**STAFF REPORT**  
**COMMUNITY DEVELOPMENT DEPARTMENT**

DATE: 3/2/2021  
 TO: Mayor & City Council  
 FROM: Joseph Dodson, Associate Planner  
 208-884-5533  
 SUBJECT: FP-2020-0019  
 Jocelyn Park No. 1

A final plat consisting of forty-one (41) building lots and seven (7) common lots on 10.15 acres of land in the R-8 zoning district. *This is the first final plat for Jocelyn Park Subdivision (H-2020-0067).*

B. Final Plat (dated: December 15, 2020)

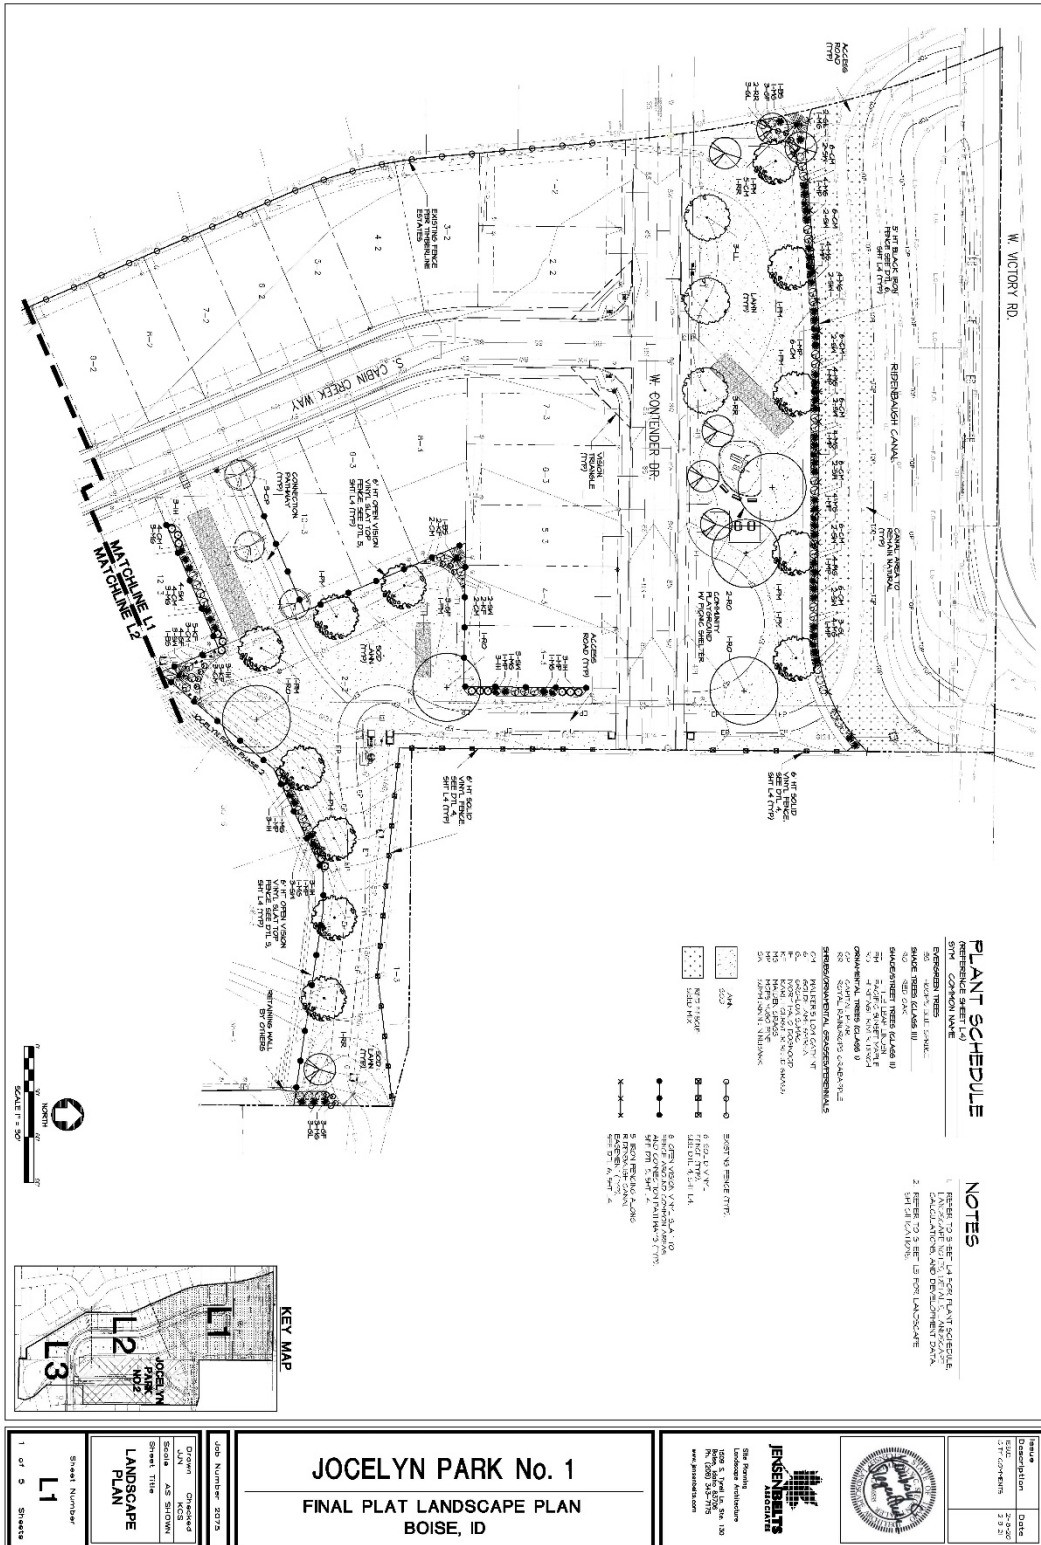
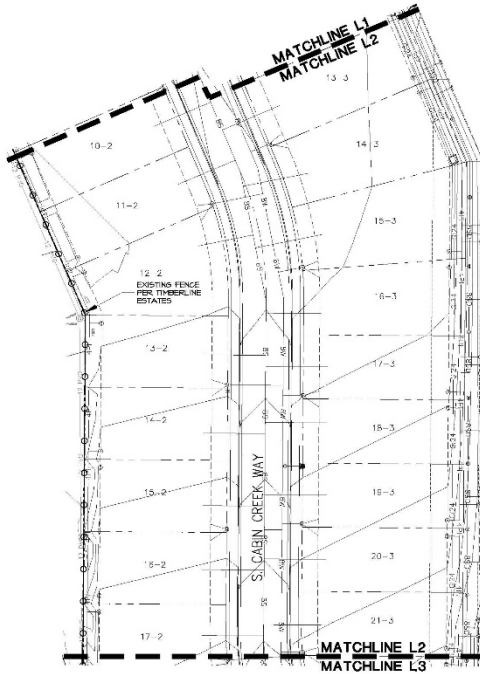
3. Prior to submittal for the City Engineer's signature, have the Certificate of Owners and the accompanying acknowledgement signed and notarized.
4. Prior to signature on the final plat by the City Engineer, the final plat prepared by Land Solutions (Exhibit B), dated December 15, 2020, shall be revised as follows:

- a. Remove Note #10 as this development is not bound by a Development Agreement.
  - b. Note #12: Include recorded easement instrument number.
  - c. Note #13: Include the recorded instrument number.

C. Landscape Plan (dated: February 3, 2021)

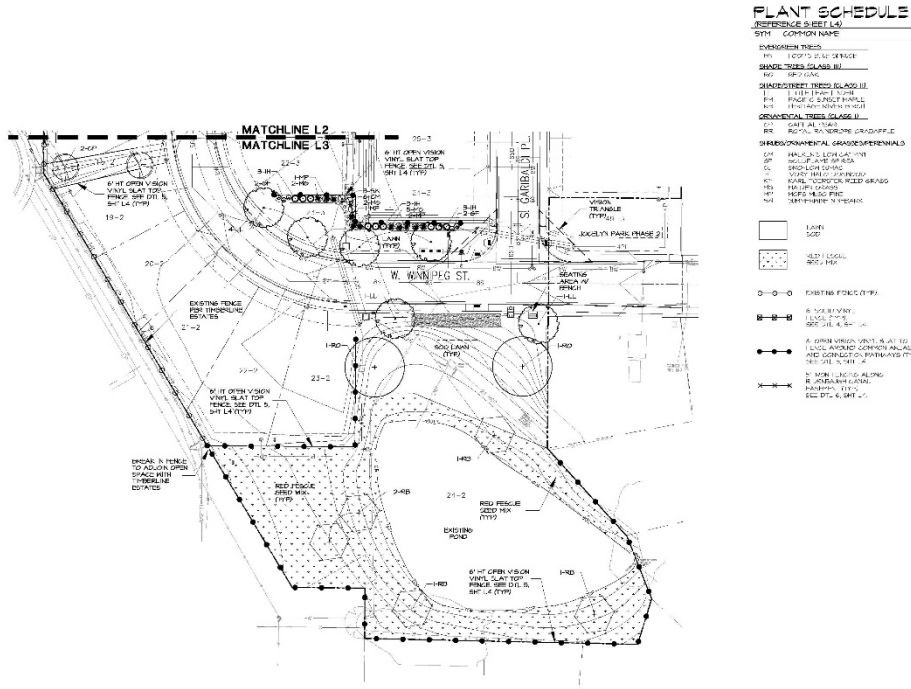
5. Prior to signature on the final plat by the City Engineer, the landscape plan prepared by Jensen Belts Associates (Exhibit C), dated February 3, 2021, shall be revised as follows:

- a. Revise the required seating amenity located on Lot 24, Block 2 to be a more substantial seating area that is more than just a bench adjacent to the sidewalk to meet the recommendation of the Planning and Zoning Commission.
